## **PRODUCT SERVICE BULLETIN**

**Bulletin Number: PSB 01-2015**

**Subject: Vigil Cutters manufactured March 2015 – July 2015  
(03/2015 – 07/2015)**

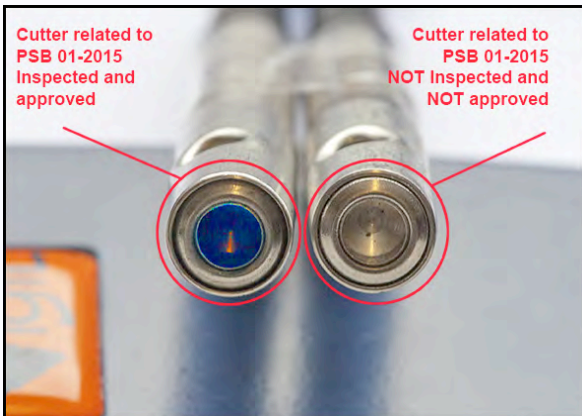
Upon investigating a report of a severed closing loop, it was determined that a rough edge inside the cutter abraded the loop fabric, causing it to fail.

Inspection of other cutters revealed a limited range of cutters which could potentially have rough edges inside. Subject cutters appear to be more likely to abrade the closing loop in equipment where the cutter is placed above the pilot chute. We do not expect to find that every cutter in this range of cutters has an issue, but in the interest of safety we are requiring that every cutter in this range be inspected.

A.A.D. nv/sa has determined that all cutters identified as having been produced during the specified date of manufacture range (3-15, 4-15, 5-15, 6-15 and 7-15) (mm-yy), whether or not they are installed in a harness-container-AAD system, must be recalled for in-house microscopic inspection at A.A.D. nv/sa, and that all reserve container closing loops with which a subject cutter was used must be replaced.

After inspection of the returned subject cutter by A.A.D. nv/sa, a blue paint dot will be placed on top of the cutter to indicate that the cutter has been inspected and approved by A.A.D. nv/sa. A cutter will be returned, which will be accompanied by a new service card, dated and signed with a special stamp, confirming the inspection of the cutter.
